RIIO-2 CHALLENGE GROUP INDEPENDENT REPORT FOR OFGEM ON RIIO-2 BUSINESS PLANS

24 January 2020

Chart 1: Incidents (explosions) caused by the Main and Services through time (all GDNs)¹³

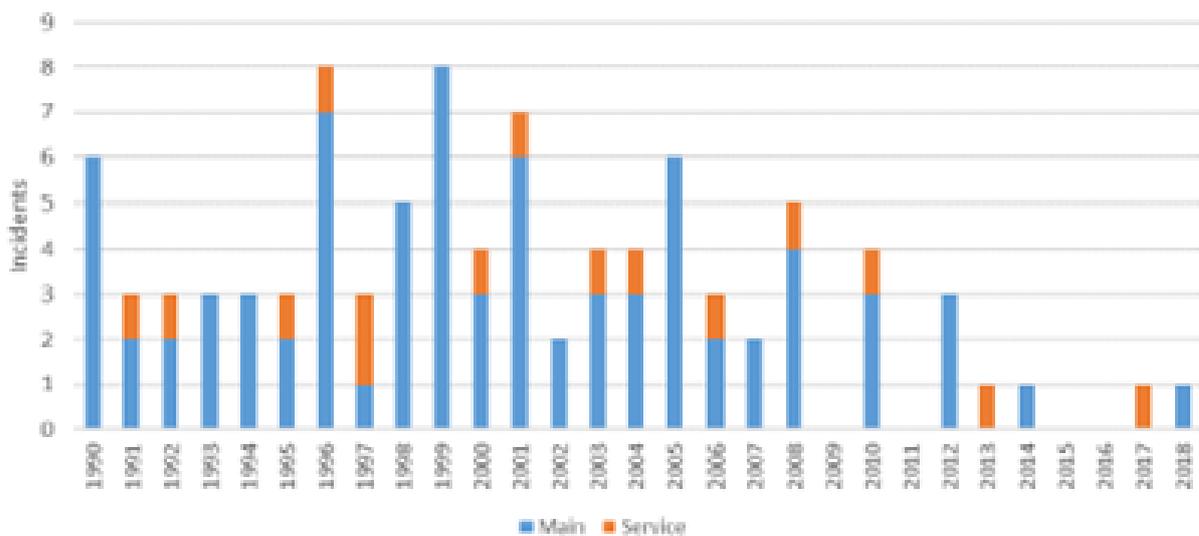
- Mains replacement – mandatory and non-mandatory. Cadent has provided the chart 1 showing a decline in mains incidents since 2010. Given the declining risk compared to the vast expenditure planned for mains replacement, we would suggest that an urgent review takes place to consider if the mandatory replacement programme should continue at current levels.

Figure 09.08: RIIO-1 vs RIIO-2 average totex (18/19 constant prices)

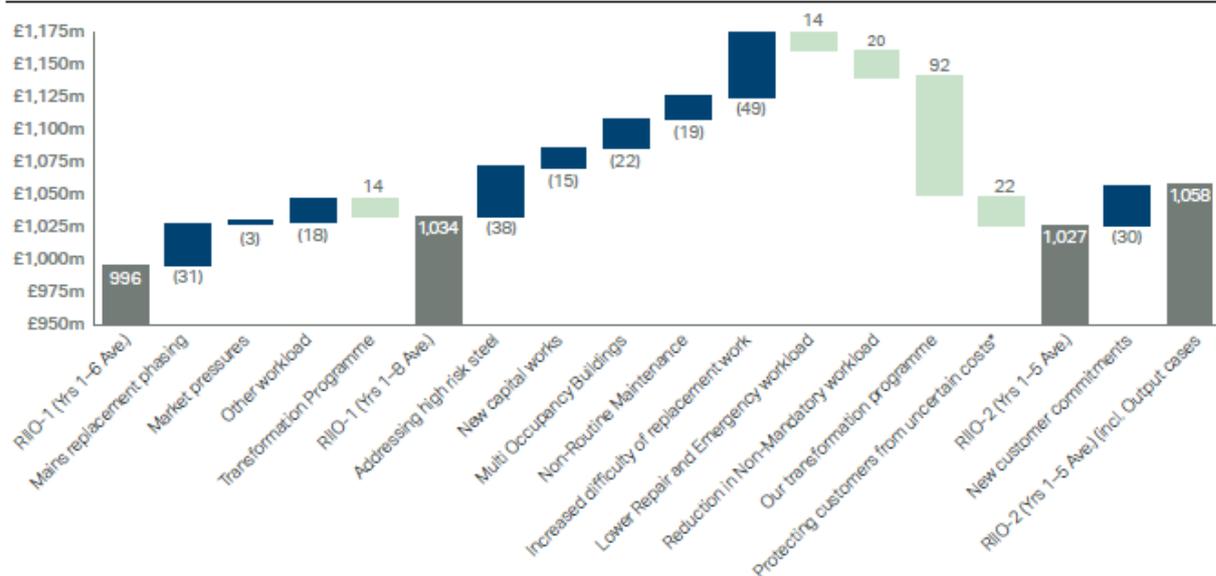
Cadent has also set out a reconciliation of changes from RIIO-1 to RIIO-2 as set out below. It identified the key upward and downward cost drivers. It also identifies £30m pa (£150m) of proposed new customer commitments, which if included would increase Totex to £1058m (adjusted) or £1063m (reported), resulting in a 1% Totex increase.

We have used the cost categories reported to Ofgem by Cadent in Business Plan data templates to assess Cadent’s Plan. These are shown in the table below and are consistent with the cost categories used in the Cadent Plan document as summarised above.

Figure 2: Incidents (explosions) Caused by Mains and Services Through Time (All GDNs)

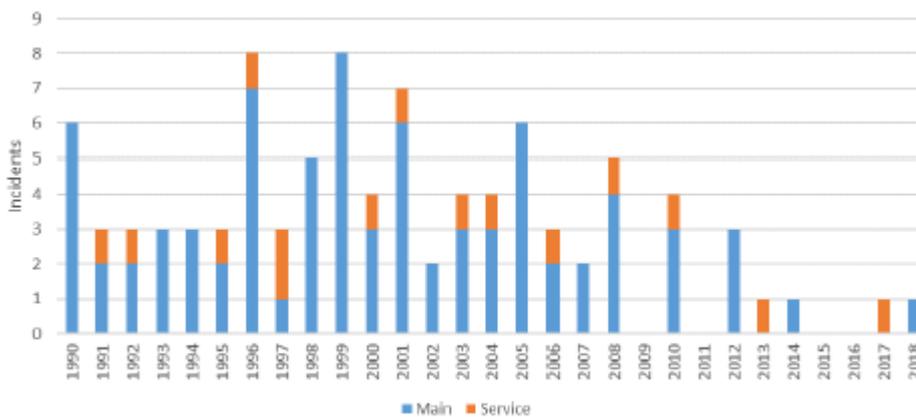
- The following chart was provided in December, indicating a significant fall in the number of incidents since 2010. As this trend applies nationally, we believe Ofgem consider whether this change in incidents should result in a reassessment of risk and the expenditure requirements. In particular if this trend continued into RIIO-2 period then it would be reasonable to challenge the 30-30 programme.

Figure 3: Benefits dependency map. (NPV = net present value.)

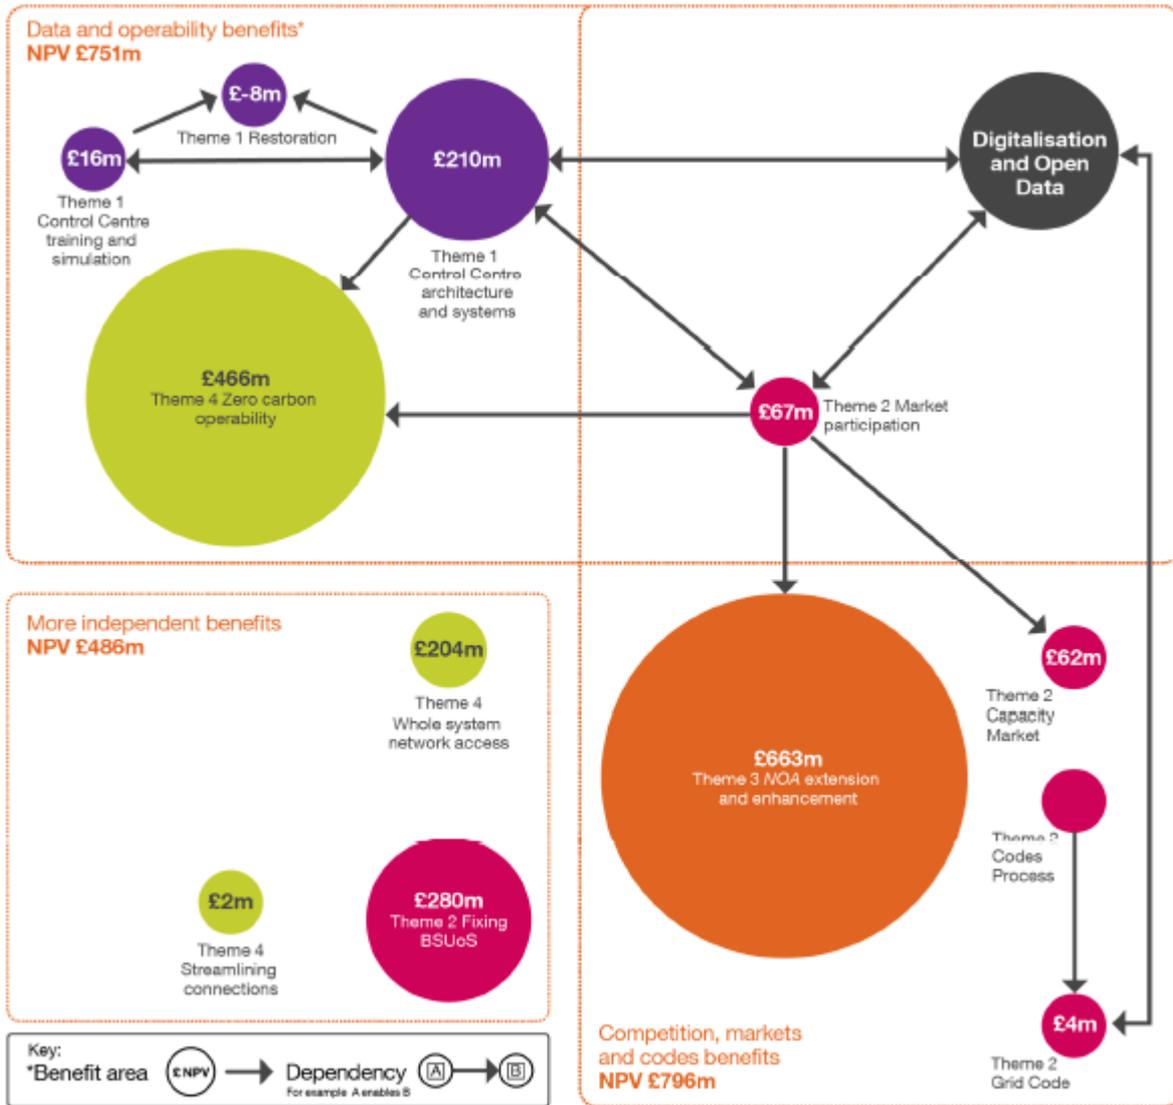
In our feedback comments to the ESO on draft plans, we highlighted that, while the CBAs take account of some potential uncertainties and risks around market, third-party and delivery factors, they are very high level and, although some different options are assessed, the key assumptions behind these calculations are not well justified.

In the December plan, the ESO sets out its CBA assumptions in the 148 pages of Annex 2 to the Business Plan. Between the October and December submissions, some additional detail has been provided, but, in the main, the changes have been to reduce the forecast benefits in Years 1 and 2 of the RIIO-2 period, while generally maintaining the forecast for the later years. This has the effect of lowering the overall 5-year NPV for the 11 CBAs from £2002m to £1967m.

Figure 14.10 Changes in Average Annual Opex between the T1 and T2 period

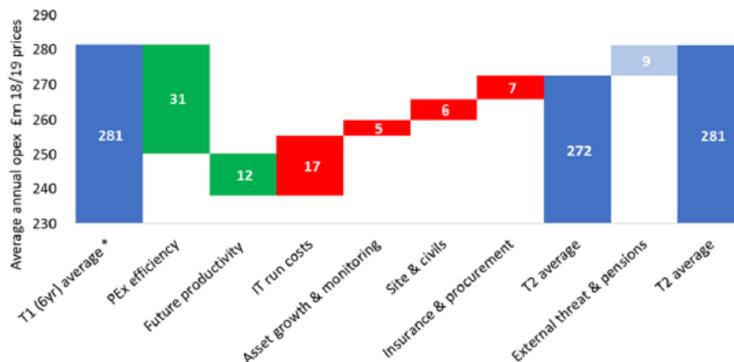
In examining the £1.4 bn of NGET RIIO-2 proposed Opex, we have used the NGET evidence in their Annex 14 – Total Opex. This proposes that average Opex costs for RIIO-2 will be £270m pa, a decrease of £10m p.a. (or around 4%) from the current run rate for the RIIO-1 1-6 year period. NGET's profile of upward and downward cost drivers behind this change is shown below.

Overall, Opex is forecast to remain flat over the period with productivity gains offset by other cost increases. With a planned investment of £380m in IT, following an expected investment of £307m during the 8-year RIIO-1, greater efficiency savings might have been expected.

Table 5. RIIO-1 to RIIO-2 changes

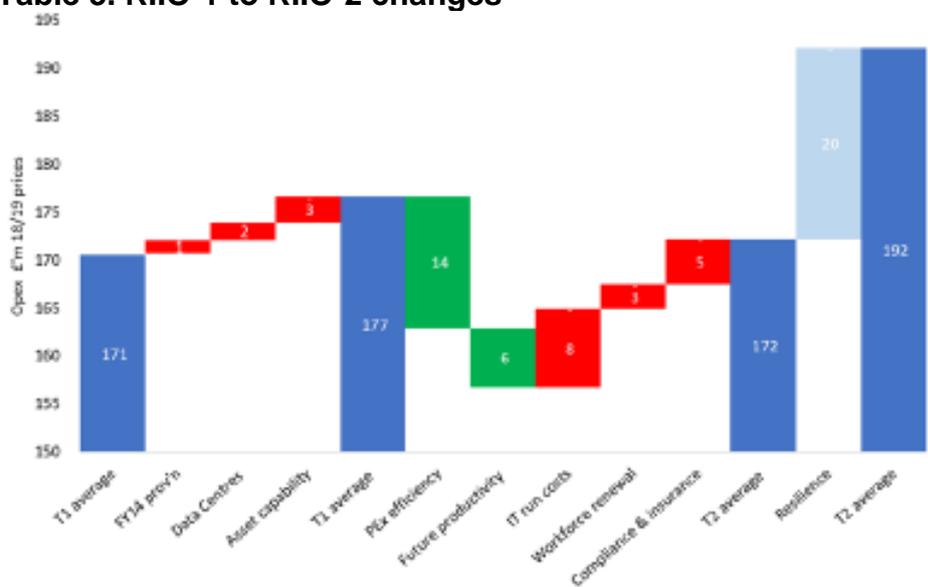
NGGT’s opex changes between RIIO-1 and RIIO-2 are shown in Table 5 below, with upwards cost drivers shown as resilience, IT costs, insurance, and workforce renewal.

IT, cyber and telecoms resilience - NGGT’s Plan includes statements forecasting expenditure on IT (£180m) and cyber/operational telecoms resilience (£417m), totalling £597m. However, the business plan data submissions show a total of £351m for IT and cyber costs excluding operational telecoms.

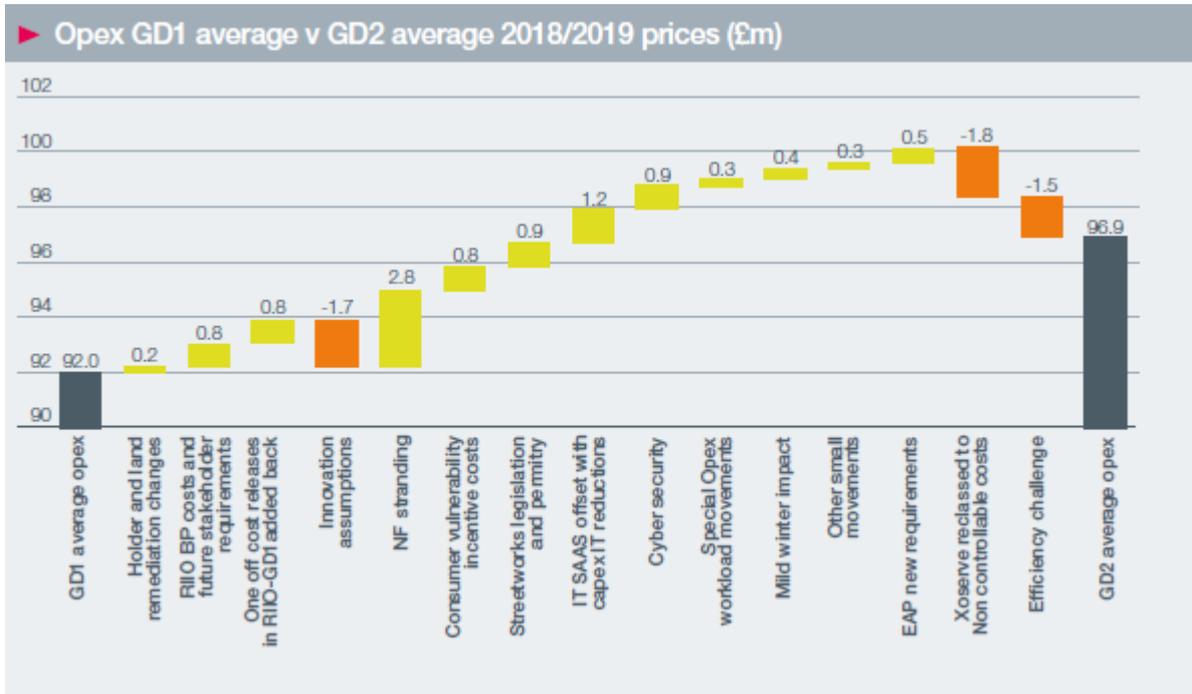
We would make the following observations from this table:

- Average Totex increases by 5% in RIIO-2 over the RIIO-1 level
- Direct Opex shows a small decrease but emergency costs show a 32% increase
- Indirect Opex increases due to a 27% increase in business support costs
- Capex - LTS, storage and entry increase by 61% and governors show a 35% increase
- RepeX – Tier 1 shows a 5% increase and Tier 2B shows a 94% increase.
